# MANAHAN PLANNERS

## RESPONSE TO REQUEST FOR FURTHER INFORMATION

**Re: Response to Request for Further Information regarding an application (Reg. Ref. SD23A/0001) for Development at Site D, Liffey Valley Office Campus, Dublin 22.**

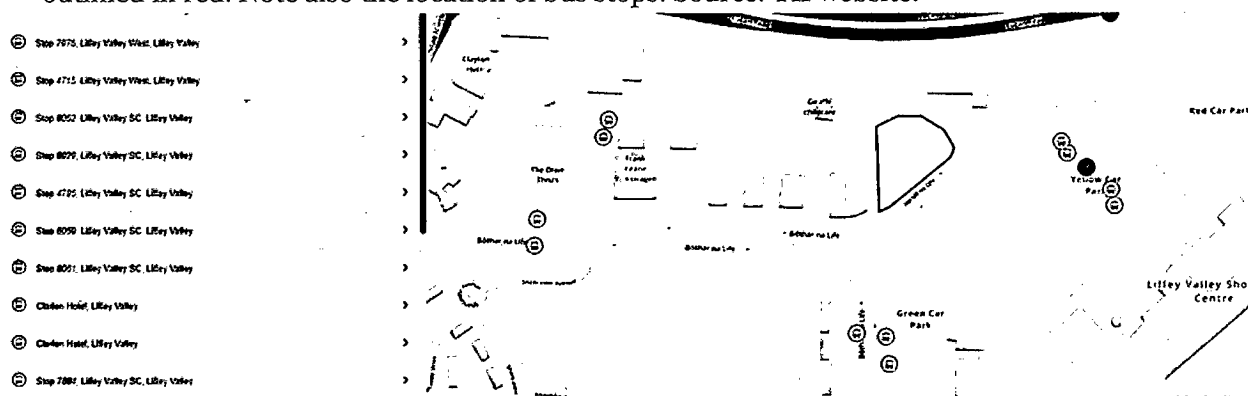
In response to Item 3(ii), the Design Team have reviewed the lay-bys to the north of the proposed building. These lay-bys are not used and were never used as a bus-stop. For many years buses did not enter into the Liffey Valley campus, despite the wishes of the owners/operators of the centre. Instead, the bus stops were located together at the edge of the campus. It was only recently (19<sup>th</sup> February 2023) that the new €20million Liffey Valley

Bus Plaza was opened as part of Bus Connects. It is very close to the site and therefore additional bus stops are not likely to be needed or developed just outside the entrance to the plaza. Such a location would be unrealistic. In the unlikely event of TII requiring the use of these laybys they have the option of making a submission to the Planning Authority, but have not done so. See image overleaf showing relationship of bus plaza to the application site, outlined in red. Note also the location of bus stops. Source: TII website.
